# Access Compliance Report

### (Curb Ramps)

Intersection ID: 18614	Main Street: HUNTER_LN	Cross Street: RANDOLPH_RD	Location: SW
ADA ID: 54CD45E792B7	Ramp Type: Perp	Initial Pass/Fail: Fail	Overall Compliance: No
Codes/Mitigation Info/Possible Solution		Field Measurements/Component Compliance	
Severity Score: 12.5

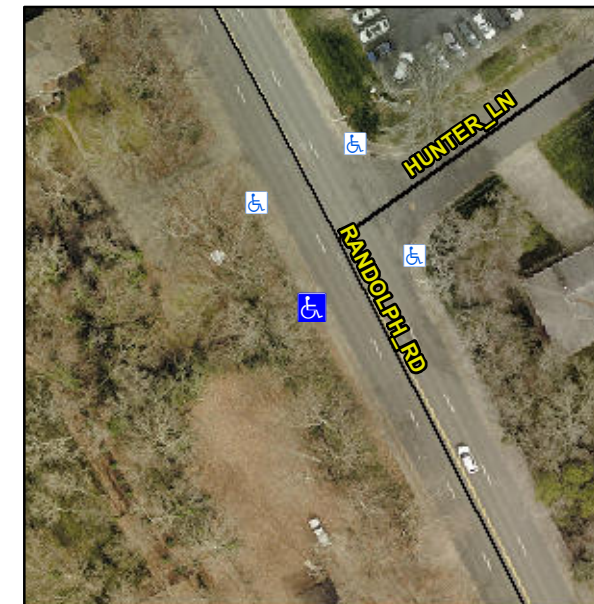
**Not Found, R304.2.2**

Compliance	Description	Data	Compliance	Description	Data
N/A	Ramp Length (in)	71.0	No	Ramp Slope (%)	8.7
Yes	Ramp Width (in)	48.0	Yes	Ramp XSlope (%)	0.1
N/A	Flare Type LT	N/A	N/A	Flare Type RT	N/A
N/A	Flare Slope LT (%)	N/A	N/A	Flare Slope RT (%)	N/A
N/A	Flare Traversable LT?	N/A	N/A	Flare Traversable RT?	N/A
N/A	Landing Length (in)	N/A	N/A	DWS Provided?	N/A
N/A	Landing Width (in)	N/A	N/A	DWS Contrast?	N/A
N/A	Landing Slope (%)	N/A	N/A	DWS Length (in)	N/A
N/A	Landing X Slope (%)	N/A	N/A	DWS Full Width?	N/A
N/A	Landing Curb? (Y/N)	N/A	N/A	DWS Offset (in)	N/A
N/A	Shared Landing?	N/A			
N/A	Gutter Ponding?	N/A	N/A	Gutter Slope (%)	N/A
N/A	Gutter Lip Ht (in)	N/A	N/A	Gutter X Slope (%)	N/A
N/A	Painted X Walk1?	No	N/A	Painted X Walk2?	N/A
	X Walk 1 Direction	To NE		X Walk 2 Direction	N/A
N/A	X Walk 1 Width (in)	N/A	N/A	X Walk 2 Width (in)	N/A
	X Walk 1 Slope (%)	3.1		X Walk 2 Slope (%)	N/A
	X Walk 1 X Slope (%)	0.5		X Walk 2 X Slope (%)	N/A

**Remove & Replace Entire Ramp.**
